Service Manual Chassis FL4.17 AA

This Service Manual contains modified instructions and prints for the FL4.17.

For all remaining information the Service Manual FL1.14/FL2.14/FL1.16/FL2.16/FL1.17AA should be consulted.

Small signal panel

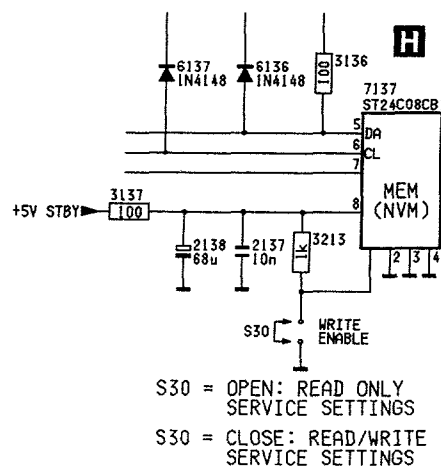
In addition the EARM protection has also been added to the small signal panel, this consists of the following modifications (see figure):

- S30 add pin strip 3P	4822 265 31009
- 3213 add 1kΩ	4822 051 10103
- 9228 add	
- 4135 remove	
- 7137 becomes ST24C08CB1	4822 209 32283
